No. EL/3.2.11

MODIFICATION SHEET NO. RDSO/WAM4/184

Tolerances between motor bars and slots to be adopted on M/s Jyoti make of Arno Convertor.

REF :	SCALE 1 : 1	APPROVED	FOR DG
DETAILS OF ROTOR SLOT CAGE BAR AND S.C.RING FOR 120KVA ARNO CONVERTOR OF M/S JYOTI MAKE			
R.D.S.O. ELECT. DTE.		SKEL-4318

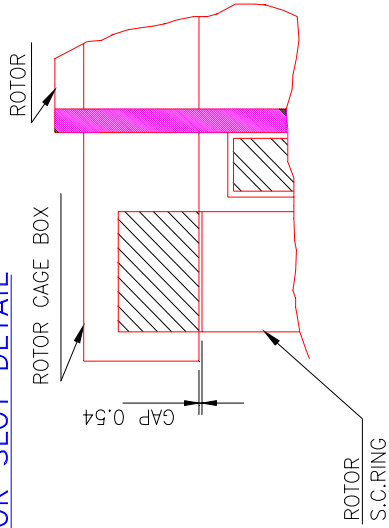
3.2 In order to arrest the cracking of rotor bars in service, it is emphasised the need for providing adequate but not excessively tight fits between the copper bar and the slots. In view of this a modification is being issued to follow carefully, the dimension and tolerances on the bars and on the slots of the rotor to be adopted.

5.1 Examine the working drawing , dimension, tolerances relating to rotor bars and slots.

5.2 Railways are advised to follow the following dimensions as furnished by M/s. Jyoti :-

Dimension	Nominal	Minimum	Maximum
Slot width	7.11	7.085	7.135
Copper bar width	6.5	6.39	6.61
Tolerance between			
slots & bar	-	0.475	0.745
Slot height	20.37	25.345	20.395
Copper bar height	20	(Not specified in IS:1897)

5.3 Following tolerances should be adopted on the rotor bars :-

Bar width	$6.5 \pm 0.11 \text{ mm}$
Bar height	$20 + 0.0 \text{ mm}$ $- 0.1 \text{ mm}$

The above tolerances will ensure that the minimum clearance is 0.345 mm. However, radial clearance has not been clearly defined in the drawings and in IS:1897 But M/s Jyoti has advised that this radial clearance will be about 0.4 mm.

- 5.4 In order to achieve the radial clearance of 0.4 mm the rotor bars must all be firmly bedded down in the core slots.
- 5.5 While repairing any rotor with cracked bars, it is desirable to replace all the bars and both the end rings i.e. old bars and rings should not be reused.
- 5.6 Rotor bars should be "Araldited" only in the middle third of the rotor slots leaving the end third portion free for expansion and contraction.
